**MONTGOMERY COUNTY PLANNING DEPARTMENT**  
THE MARYLAND-NATIONAL CAPITAL PARK AND PLANNING COMMISSION

**Staff Report: Preliminary Plan No. 120090130: Star Pointe Plaza**  
**Site Plan No. 820100020: Star Pointe Plaza**

**APPLICATION DESCRIPTION:** Proposal to create one 1.54 acre lot and construct a 25,239 square foot, three-story commercial building consisting of general office space, retail and restaurant; 1.54 acres; I-1/Burtonsville Employment Area Overlay Zone; located on Sandy Spring Road, approximately 100 feet west of Star Pointe Lane; Fairland Master Plan.

Figure 3: Illustrative Plan

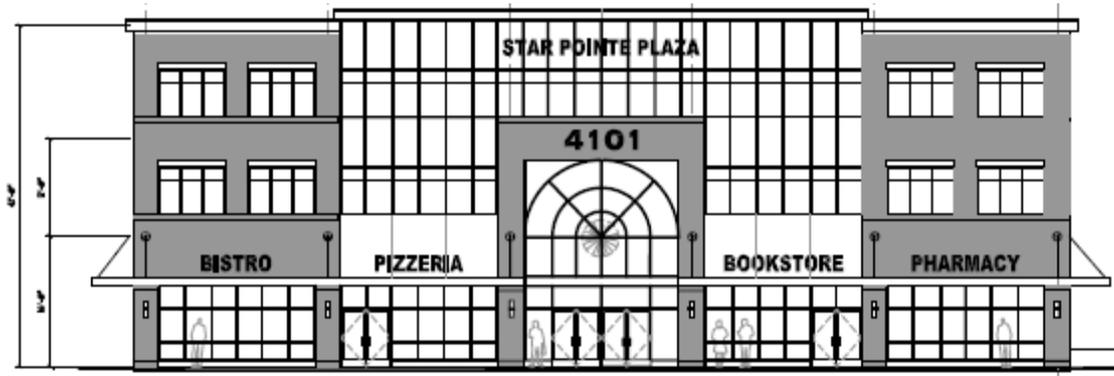
Concerning the above plan, I attended two community meetings hosted by the developers (I believe in July 2008 and spring, 2009). At both meetings, the location of the building was at least 100 feet further south from Route 198 than the current plan. Why has the location changed ?? When US Storage, now Extra Space storage, was developed in the late 1990's in the same zoning area, my neighbors and I were told by MD-NCPPC that the building would be shielded from Route 198 and all access would be from within the industrial zone. This plan violates those restrictions, why the change ?

Thank you for sharing your concerns on the building location for the Star Pointe Plaza site plan in your letter of October 1, 2009. We understand that the building location has changed from earlier versions as presented to your community. However, Staff believes that the new location is still in conformance with the Fairland Master Plan, and results in a better and more efficient layout for this site.

The new building is now perpendicular to MD 198 (rather than parallel) and located approximately 90-feet closer to MD 198 than the original version. Given the triangular shape of the property, the new location allows for a more efficient layout with the parking consolidated in one area, vehicular circulation looping through the site, and the storm water management facility located underground rather than in the front of the site. This layout responds adequately to the existing access to the site from the service drive on MD 198, while it also accommodates the plans of a future access from the future Dino Drive. Pedestrian access is safer in the new layout because there is a longer stretch of continuous sidewalk (with less crossing points) from MD 198 and the proposed building entrance. The area between the building and the service drive will be landscaped to provide screening and an amenity area for the office workers and retail patrons of the proposed building.

7. Site Design
  - a. Enlarge outdoor plaza area along the northern façade of the building to a minimum of 400 square feet.
  - b. The exterior architectural character, proportion, materials, and articulation must be substantially similar to the schematic elevations shown on Sheets A1.1 and A2.1 of the submitted architectural drawings dated May 27, 2010, as determined by M-NCPPC Development Review and Urban Design staff.
  - c. Provide five (5) inverted-U bike racks at the main entrance of the building with 2.5 feet minimum distance between the racks.

Figure 7: Preliminary Plan

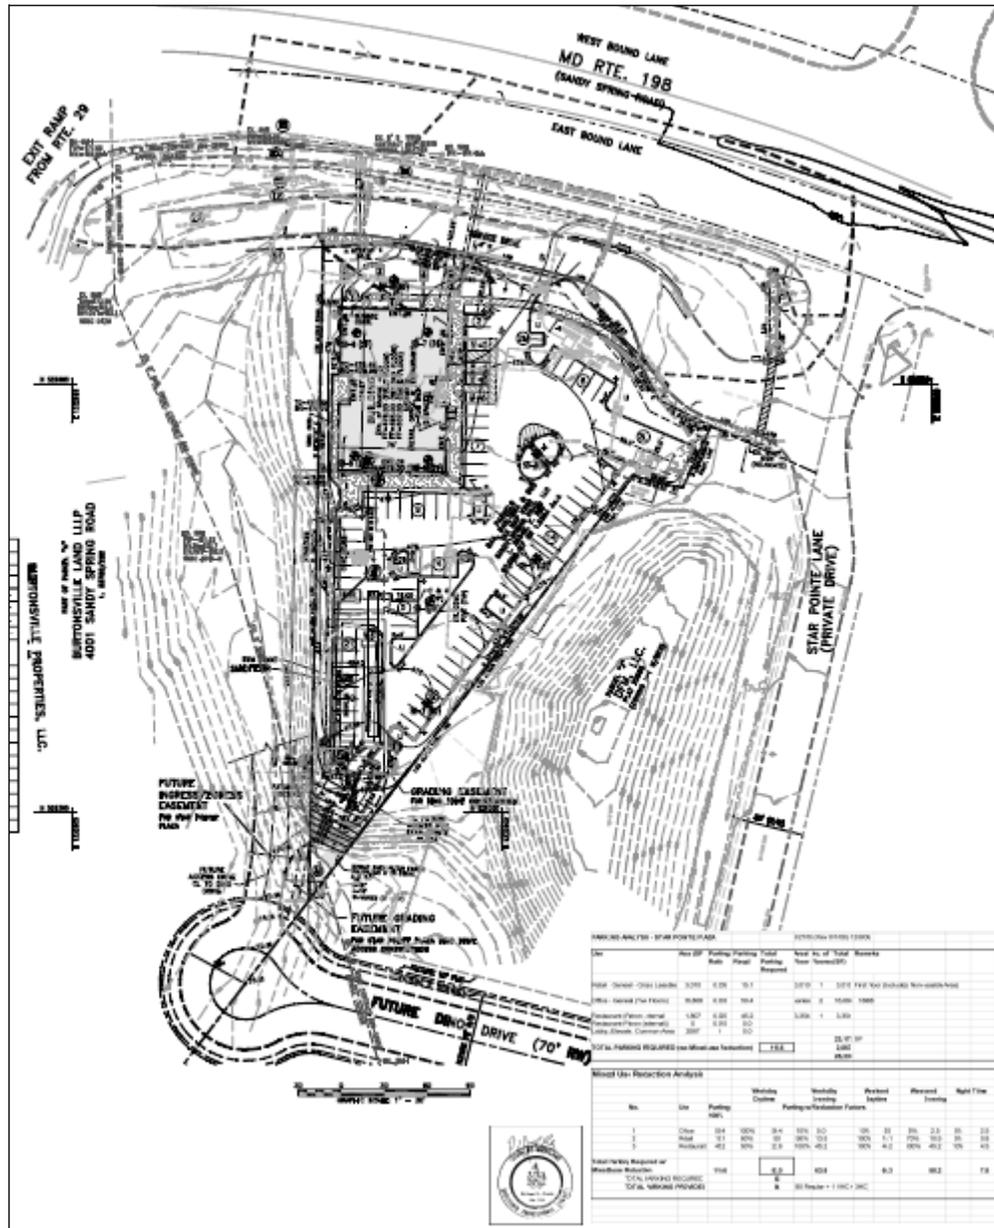
- 1) Approval under this preliminary plan is limited to one lot for 3,100 square feet of retail use, 3,260 square feet of restaurant use, and 16,808 square feet of general office use.

- 5) The Applicant, in coordination with Burtonsville Land LLLP (a.k.a. EZ Storage/Siena Corporation – Burtonsville Industrial Park; Preliminary Plan No. 120070510), must construct a site access driveway from Dino Drive in the event that the Maryland State Highway Administration (MDSHA) closes site access to the existing service road accessing Sandy Spring Road. At that time, the Applicant must also close the proposed temporary driveway to MD 198 via Star Point Drive and the service road and relocate the site access to the Dino Drive driveway.

- 6) The Applicant must satisfy MCDPS requirements prior to recordation of the plat to ensure the construction of offsite sidewalks near the property frontage on Sandy Spring Road (MD 198) as shown on the preliminary plan.

3. Pedestrian Circulation
  - a. Provide lead-in sidewalks, internal sidewalks, and a crosswalk on the northern portion of the site, as shown on the preliminary plan.
